COMMISSION ON COMMUNITY INVESTMENT AND INFRASTRUCTURE

RESOLUTION NO. 44-2022

CONDITIONALLY APPROVING THE SCHEMATIC DESIGN OF A MIXED-USE AFFORDABLE HOUSING PROJECT OF APPROXIMATELY 151 RENTAL UNITS FOR SENIORS AND APPROXIMATELY 2,945 SQUARE FEET OF COMMERCIAL SPACE AT THE WESTERN HALF OF BLOCK 2 OF ZONE ONE OF THE TRANSBAY REDEVELOPMENT PROJECT AREA; TRANSBAY REDEVELOPMENT PROJECT AREA

EXHIBIT A: Schematic Design Document for the Transbay Block 2 West Project

Block 2 Project Loading Scenario

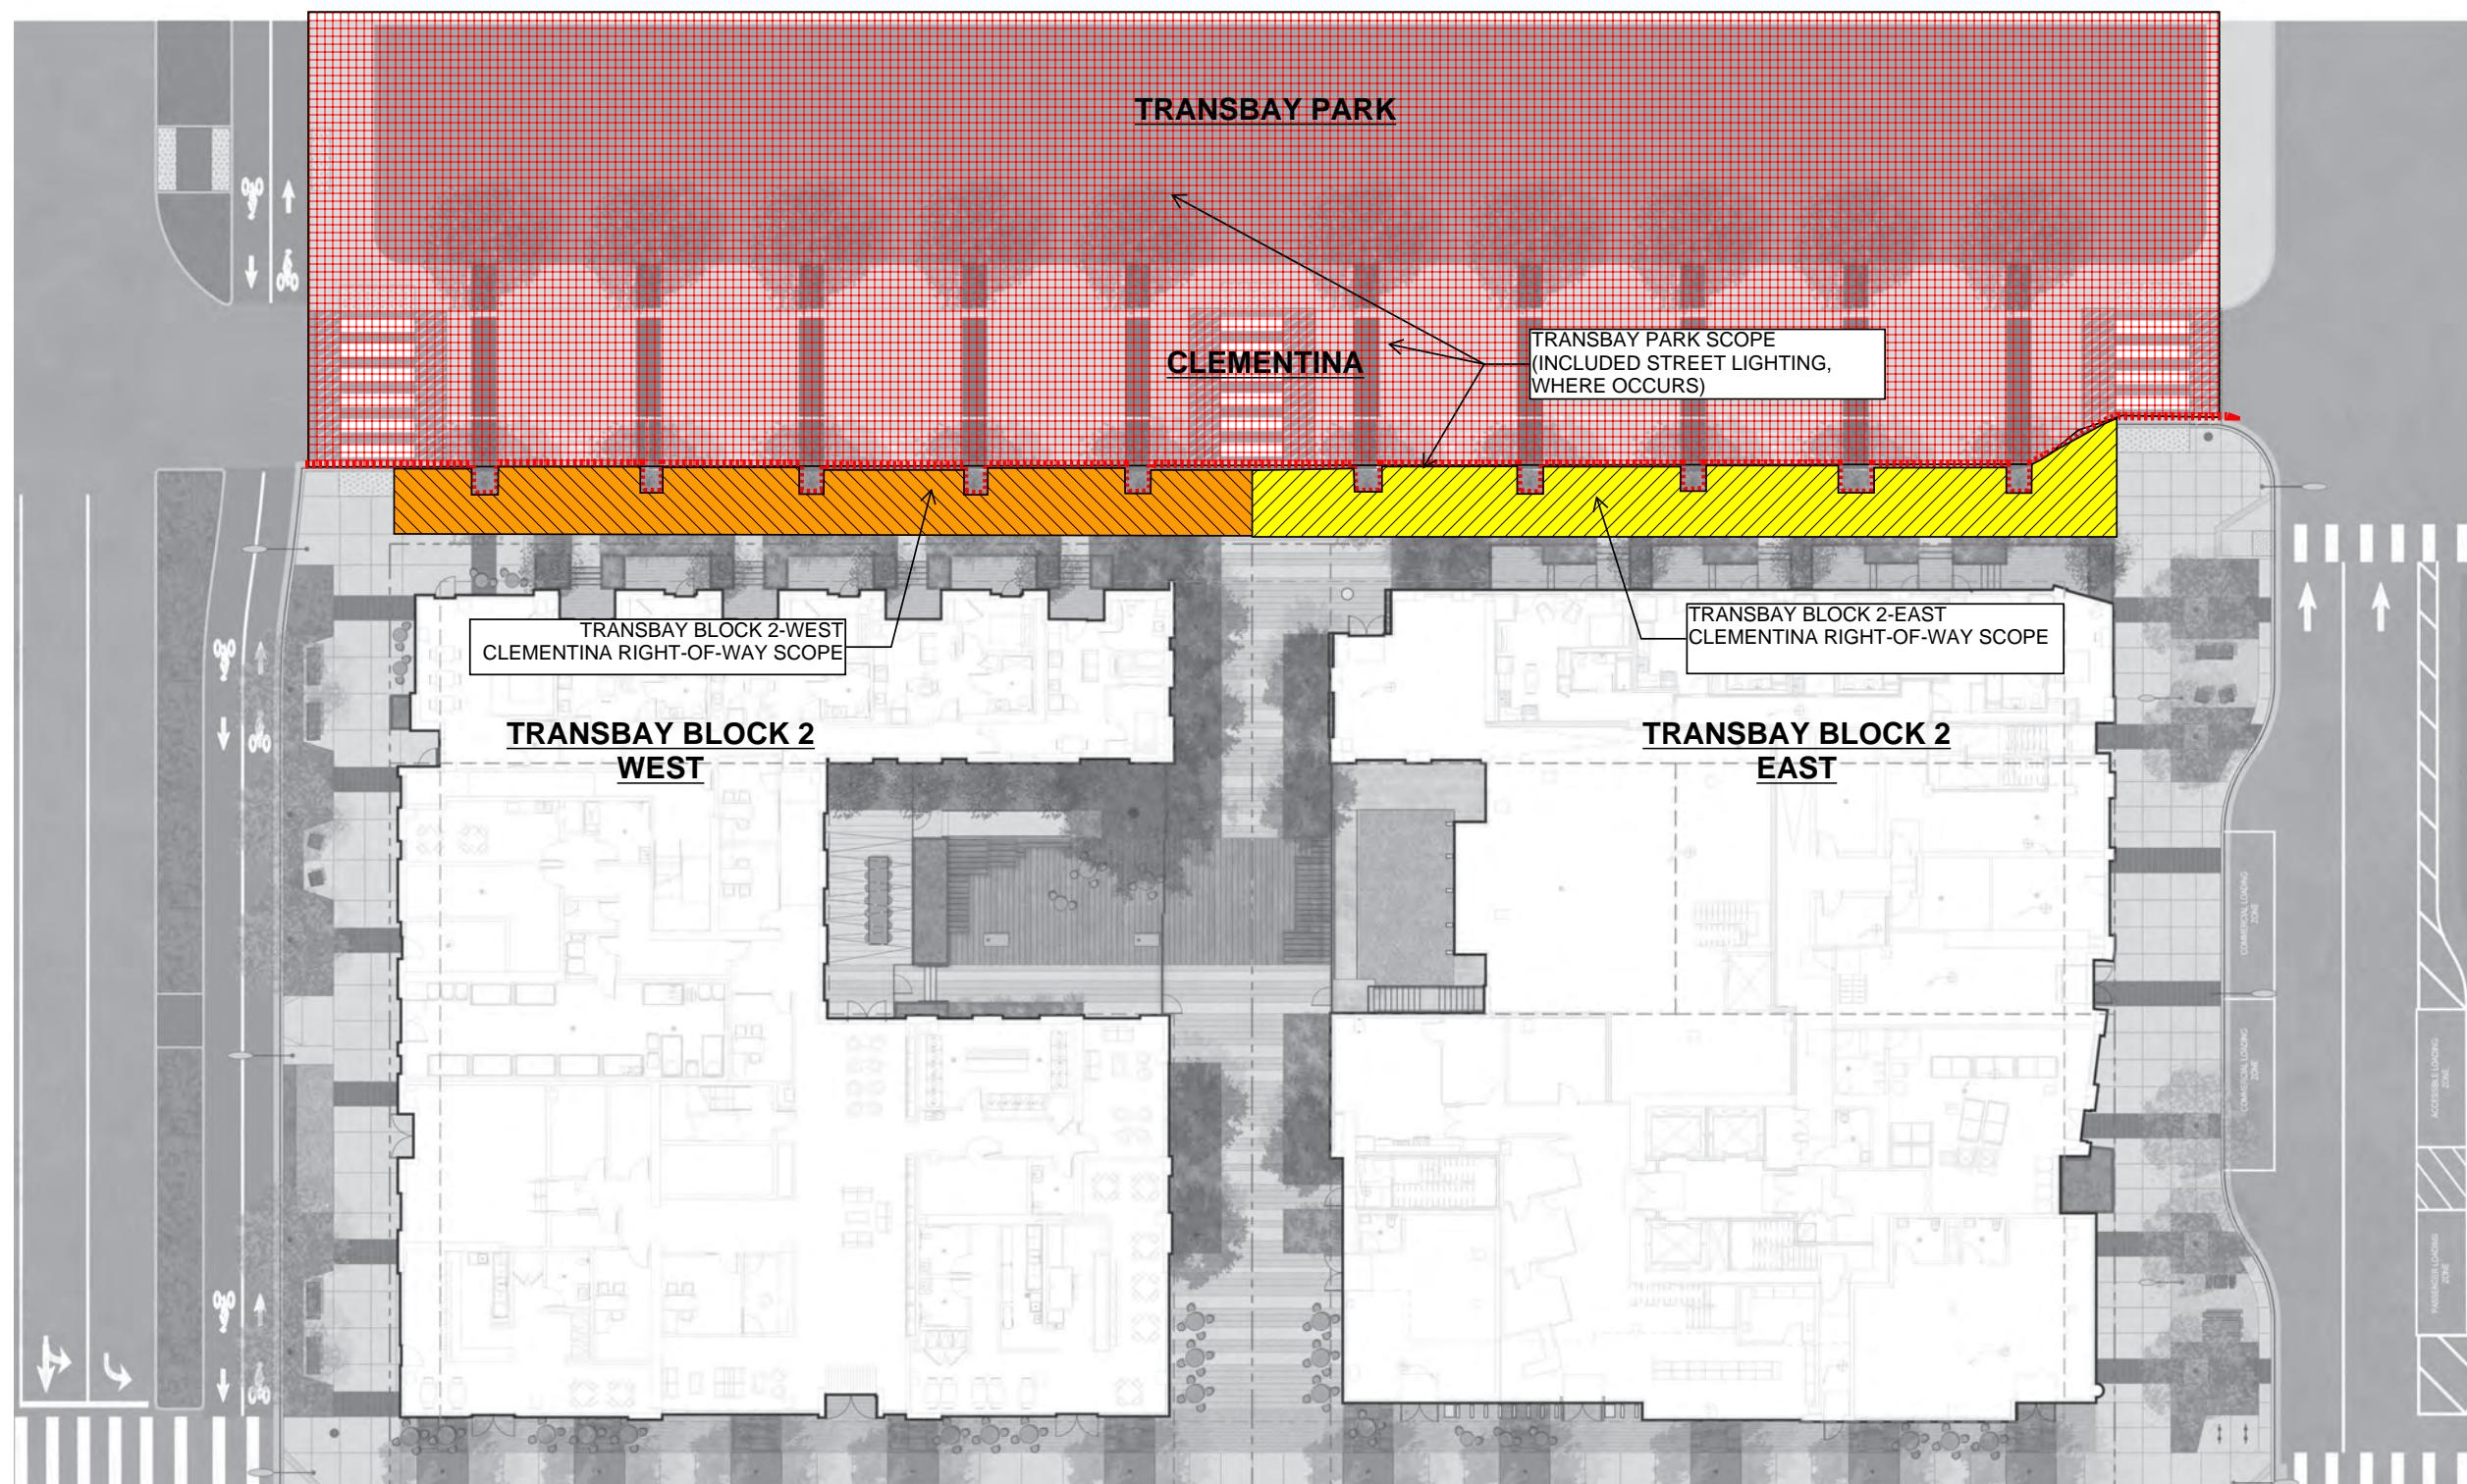
WHEREAS, The Development Controls allow the Agency to establish a lower ratio of off-street loading spaces than what would otherwise be required, based on a development-specific loading scenario. The Development Controls require a ratio of one off-street loading space for a development the size of the Block 2 Project. The Co-Developers prepared a development-specific loading scenario that proposed the Block 2 Project’s loading demand be met at designated on-street loading spaces surrounding the Site without the provision of an off-street loading space, curb cut or driveway (“Block 2 Project Loading Scenario”). The Block 2 Project Loading

Scenario is on page 84 of the 2 West Project Schematic Design Document and has been reviewed by OCII staff, by City staff at the San Francisco Public Works and San Francisco Municipal Transportation Agency departments, and by representatives of the City's waste management contractor, Recology, who have determined that the Block 2 Project Loading Scenario adequately fulfills the requirements to meet the Block 2 Project's future demand for commercial and residential loading, ongoing commercial and residential pick-up and delivery of goods and waste products, and passenger pick-up and drop-offs, without the need for an off-street loading space on the Site; and,
